In the drawings

In the current Office Action, the drawings were objected to as failing to comply with 37 CFR 1.84(p)(5) because they do not include the reference signs for reference numbers 30 and 32. In response, Applicants herewith submit formal drawings having amendments that comply with the 37 CFR 1.84 rules. The reference numbers and drawing details were omitted in the originally filed application by typographical error. However, the current amendments correcting these drawing are completely supported by the description provided in the specification as originally filed. Therefore, the amendments to the drawings do not constitute new matter.

Fig. 2

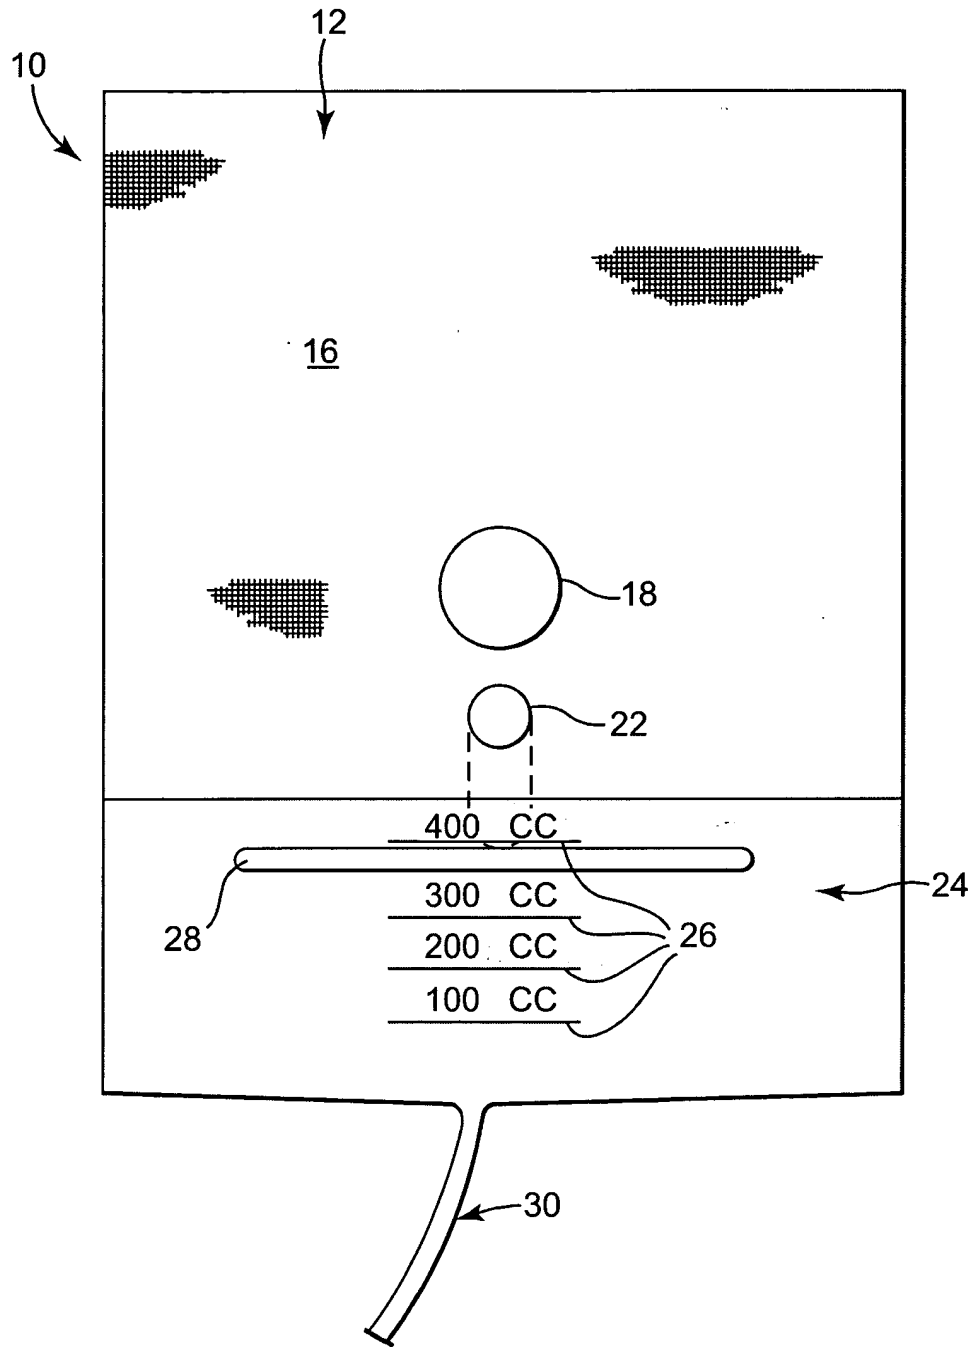
A location for the drain port 30, at figure 2, is explicitly described in page 6, paragraph 26. Amended figure 2 reflects that the drain port 30 is in fluid communication with the pouch, as recited in the specification.
